UNITED STATES PATENT AND TRADEMARK OFFICE

10/587,379

Office Action Summary	Application No. 10/587,379	Applicant(s) YAZAWA, KAZUAKI	
	Examiner Robert J. Hoffberg	Art Unit 2835

Detailed Action

FIG. 2

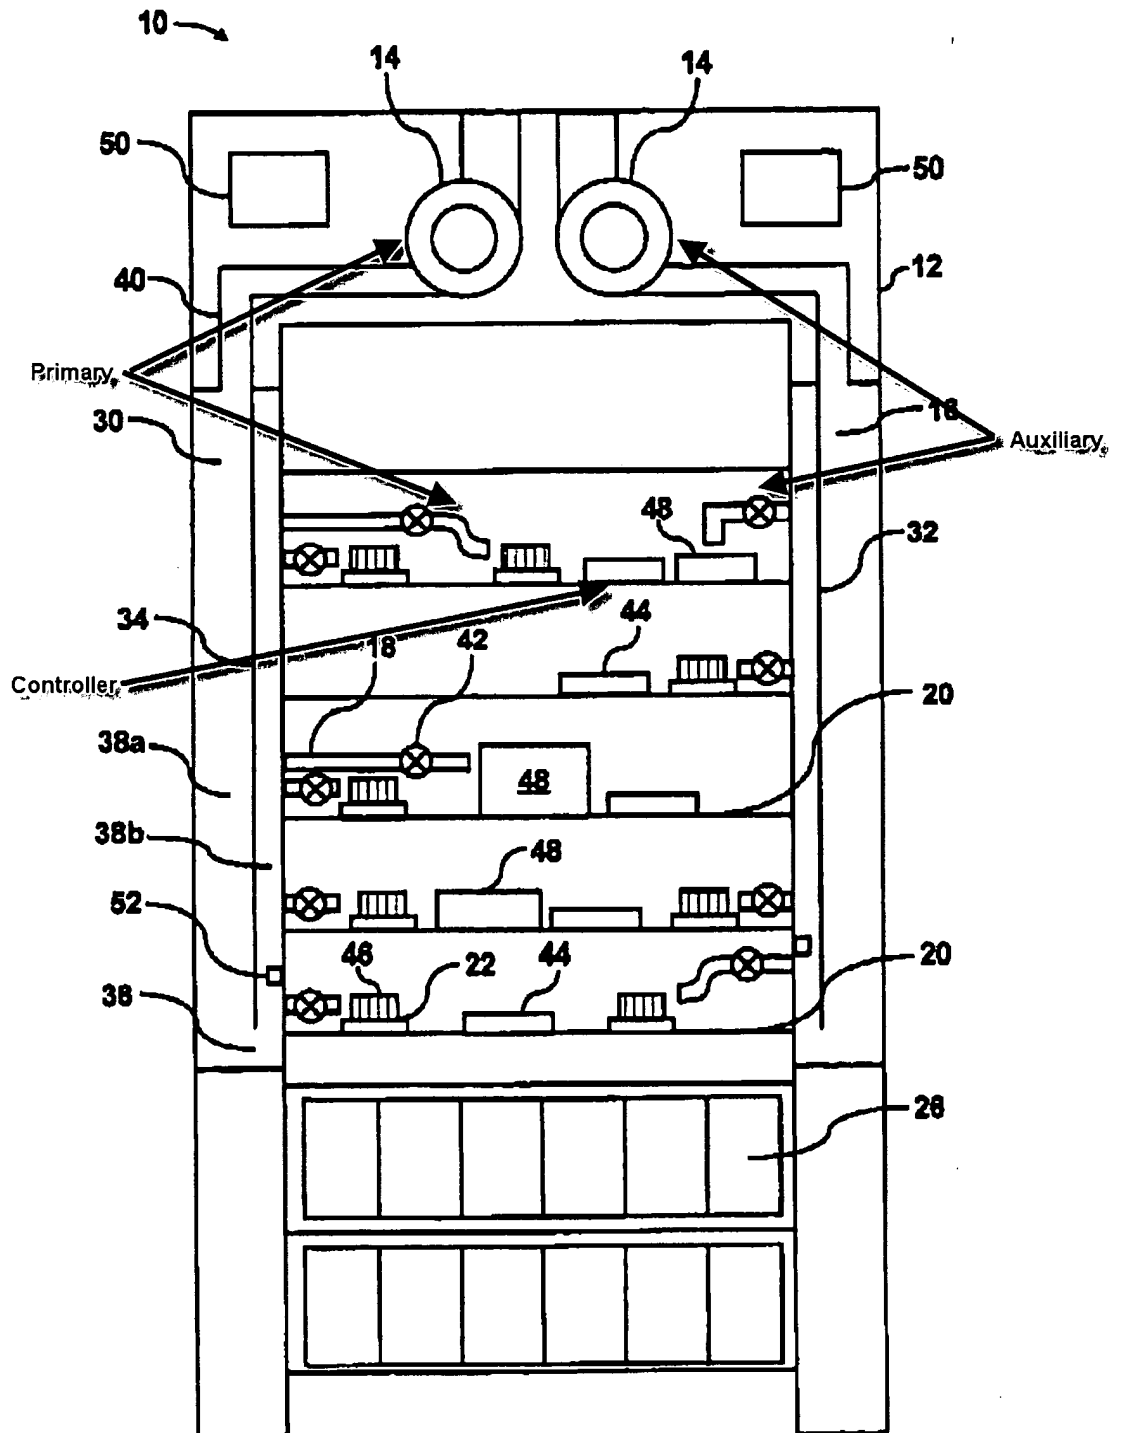
8. Claims 1 and 5 are rejected under 35 U.S.C. 102(e) as being anticipated by Beitelmal et al. (US 6,904,968).

With respect to Claim 1, Beitelmal et al. teach an electronic device cooling apparatus comprising: a primary cooling unit (Fig. 2, 14 left side & 18 upper-left), which is disposed in close proximity with an electronic device (48 upper-right) so as to face a surface (48 left side) thereof; an auxiliary cooling unit (14 right side & 18 upper-right) which is disposed in close proximity with the electronic device so as to face a surface (48 top) thereof; and a controller (44) which drives the auxiliary cooling unit so as to cool the electronic device.

With respect to Claims 4-5, Beitelmal et al. further teach the auxiliary cooling unit faces a surface (48 top) of the electronic device different from a surface (48 side) that the primary cooling unit faces.(claim 4) and the auxiliary cooling unit is provided with a cooling nozzle (18), and the controller controls (Col. 7, lines 19-21) a coolant (Col. 7, line 21) introduced in the cooling nozzle and drives the auxiliary cooling unit by delivering a jet (Col. 1, line 10) of coolant from the cooling nozzle (claim 5).
